SERVICE BULLETIN

PURPOSE : INFORMATION	ISSUE NO. : MSB-11E51-001	DATE : 2011-01-20
SUBJECT : WIPER INSTALLED POSITION (LHD VEHICLES)		<MODEL> (EUR/RUSSIA) OUTLANDER (CW0W) <M/Y> 10–11
GROUP : EXTERIOR

In order to improve the functionality, the installed position of wiper arm and blade assembly for LHD vehicles has been changed. According to this change, descriptions are changed in the applicable Workshop Manuals. This Service Bulletin contains the modified descriptions.

AC606836AD

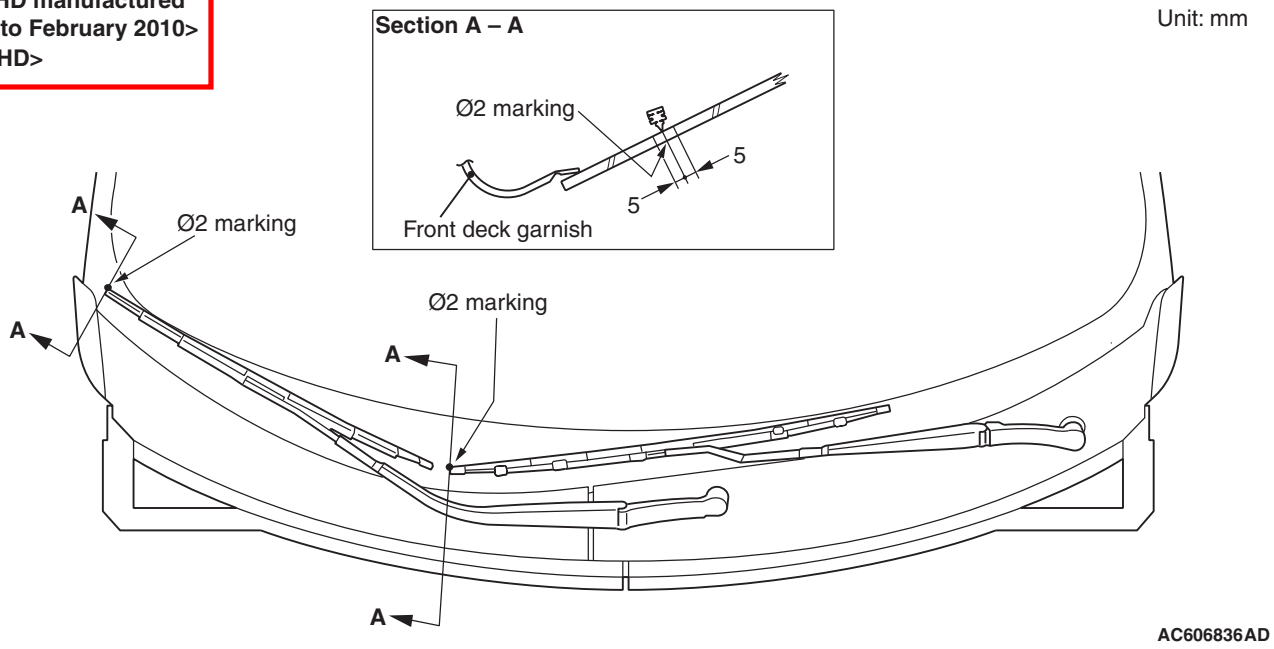
<Added>

<LHD manufactured up to February 2010>
<RHD>

Install the wiper arm and blade assembly at the specified positions.

(A): ϕ 2 marking ± 5 mm

ACA04000AB

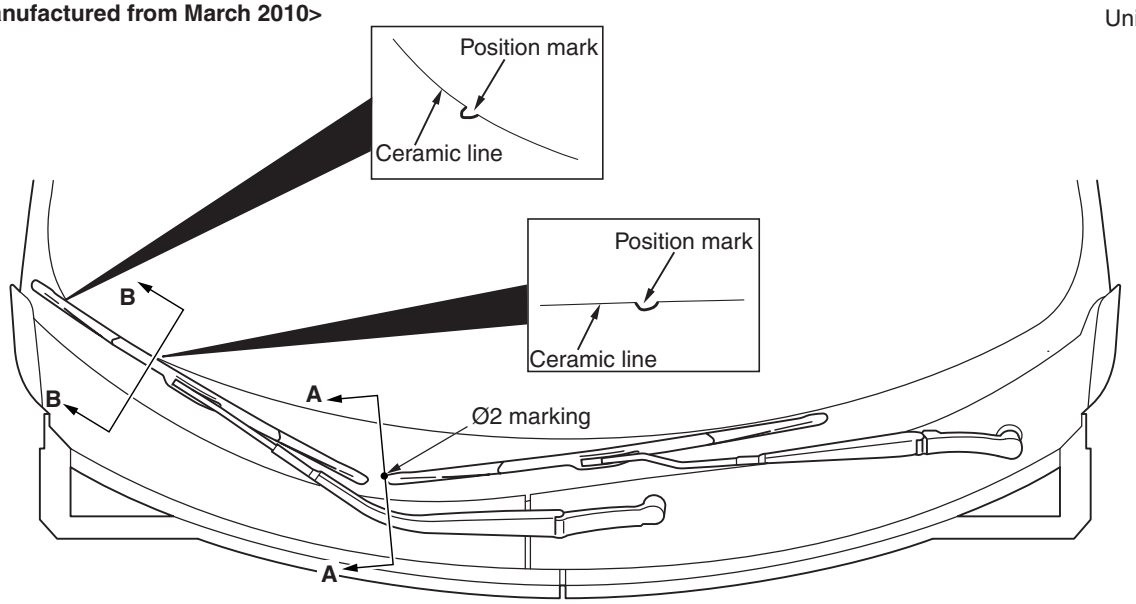
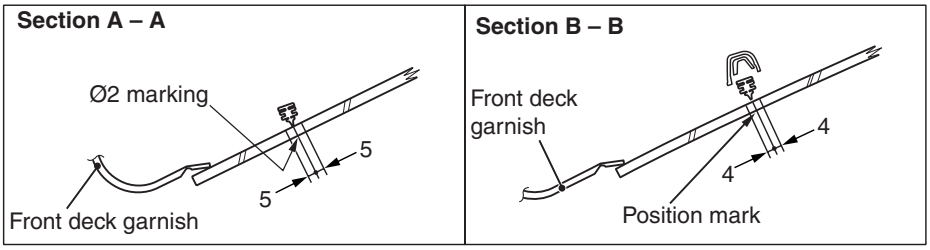
<Added>

<LHD manufactured from March 2010>

Install the wiper arm and blade assembly at the specified positions.

(A): (Driver's side):ϕ 2 marking± 5 mm
(B): (Passenger's side) : Position mark ± 4 mm

<RHD>

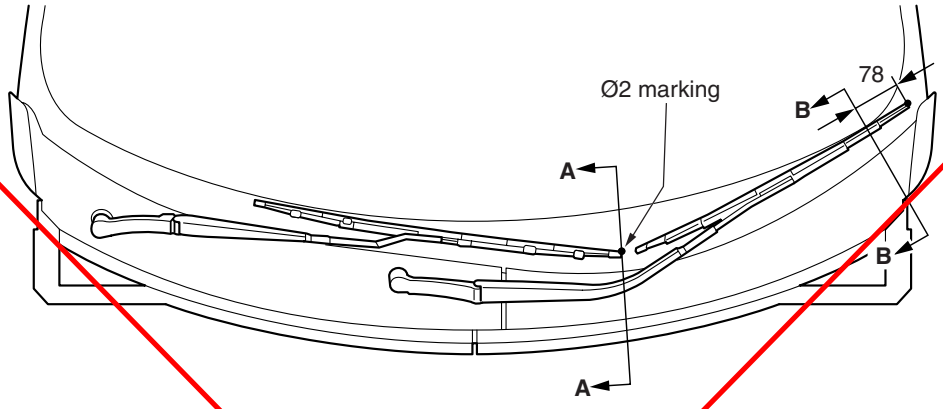
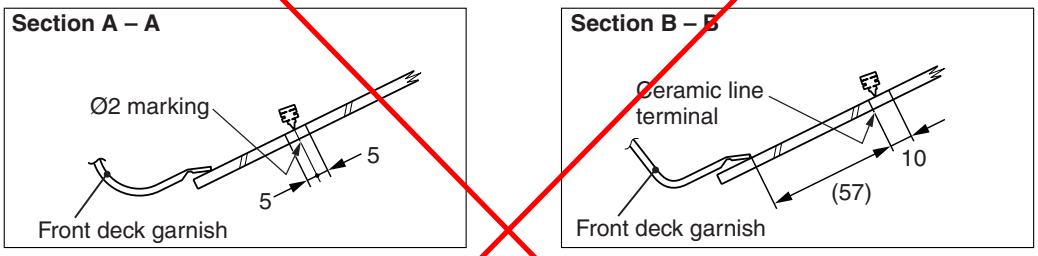
<New>

Install the wiper arm and blade assembly at the specified positions.

RHD(A) (Driver's side): ϕ 2 marking ± 5 mm
RHD(B) (Passenger's side): 0 to 10 mm from edge of the ceramic line
